DRAWING NO: MC-1419-13.20-00402	PROJECT: MCGUIRE	SYSTEM SYMBOL: MAIN STEAM	FIELD WELDS SMIF 399 THRU 404, 427 THRU 434, 910, 912, 967, 968, 971, 972 WERE DOWNGRADED TO CLASS F AND TRANSFERRED TO MCFI 15M 12.
NO.	REVISION	DATE	BY
5	ADD WELDS AT VALVE ISM 87	11-27-77	SM
4	ADD SMIF 431. IT WAS TAKEN OFF BY MISTAKE	11-27-77	SM
3	ADD TO ADD NOTE 2 AND DOWNGRADE WELDS (SEE NOTE 2) ADD CORRECT FLAG BY CHANGING CLASS PER SEC. 11.2.1	11-27-77	SM
2	CHANGE DIRECTION OF LINE AT FLANGE 1 SA 10 FL 2 (SEE DETAIL B)	11-27-77	SM
1	ADD SMIF 1062 (MATERIAL) PER V-N 29774	11-27-77	SM
0	REL FOR CONSTRUCTION	11-27-77	SM

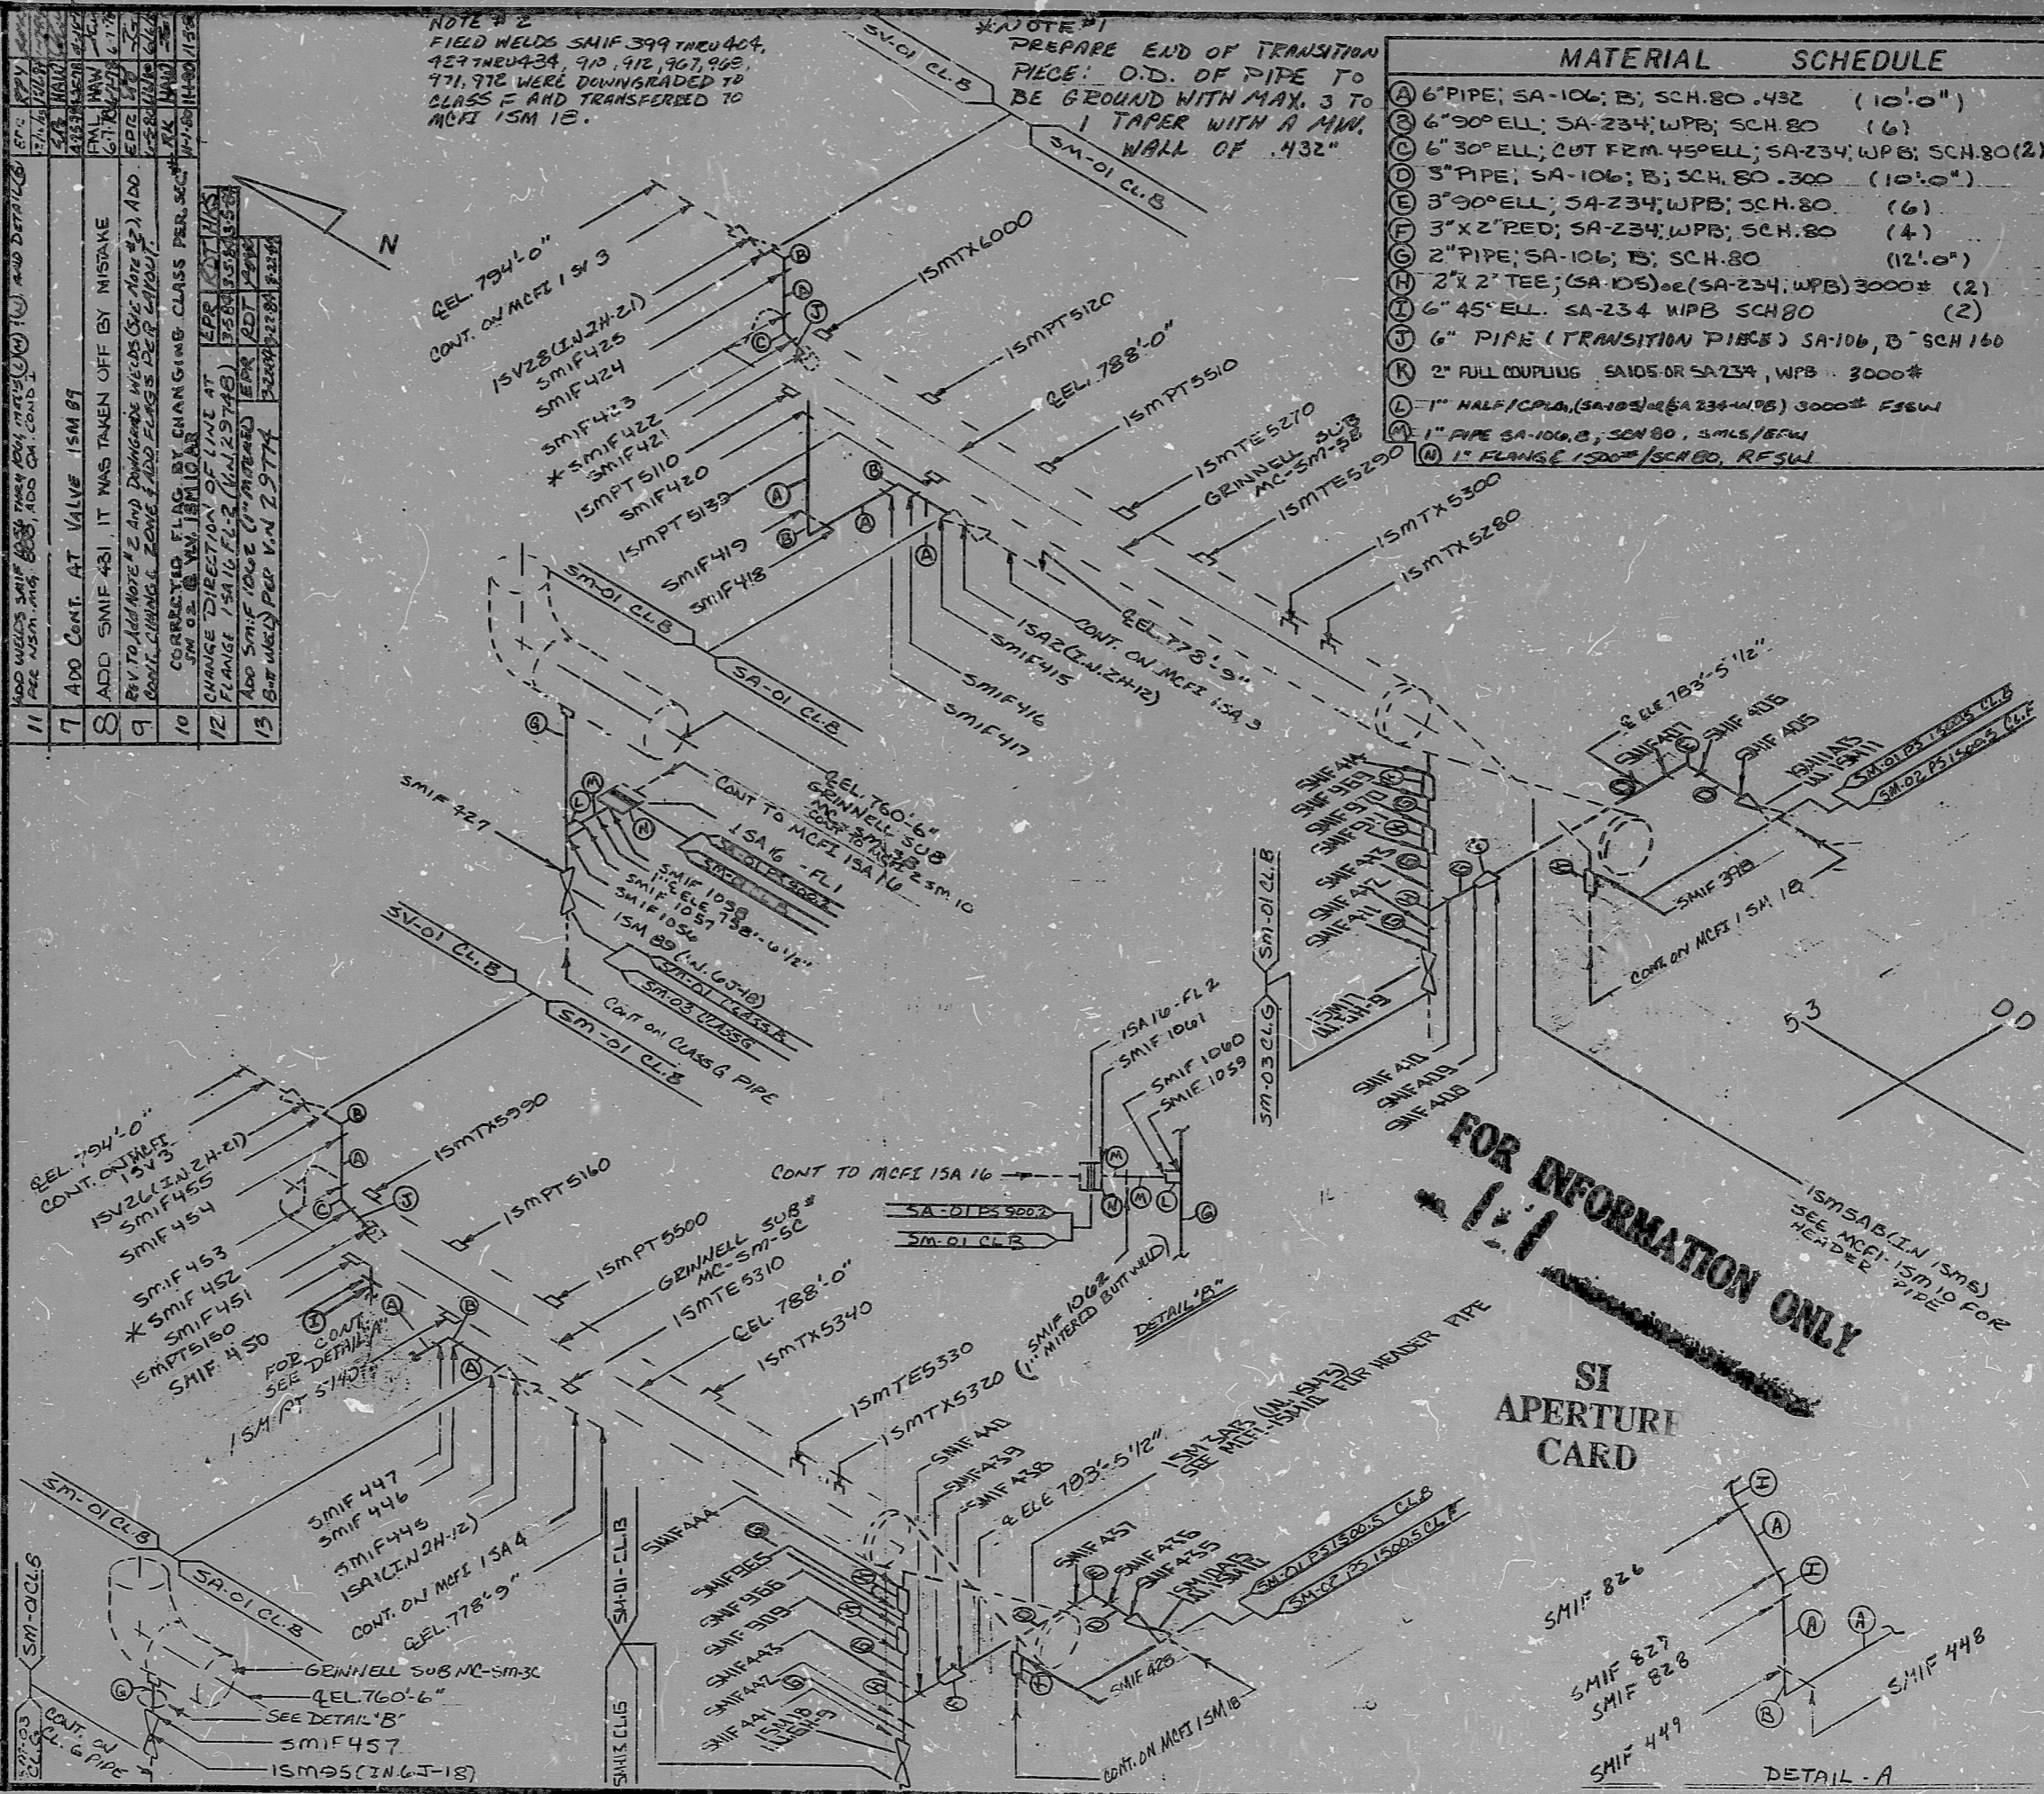
REV. 13	IN SERVICE INSPECTION	REV. 13	ADD WELDS SMIF 399 THRU 404, 427 THRU 434, 910, 912, 967, 968, 971, 972 WERE DOWNGRADED TO CLASS F AND TRANSFERRED TO MCFI 15M 12.
ISO NO: MCFI-ISM 14	DUKE PIPING CLASS: ASME SECT III CLB	ISO NO: MCFI-ISM 14	FIELD WELDS SMIF 399 THRU 404, 427 THRU 434, 910, 912, 967, 968, 971, 972 WERE DOWNGRADED TO CLASS F AND TRANSFERRED TO MCFI 15M 12.
SYSTEM SYMBOL: MAIN STEAM	PIPING SPEC: SM-01 PS-1500.5	DUKE PIPING CLASS: ASME SECT III CLB	FIELD WELDS SMIF 399 THRU 404, 427 THRU 434, 910, 912, 967, 968, 971, 972 WERE DOWNGRADED TO CLASS F AND TRANSFERRED TO MCFI 15M 12.
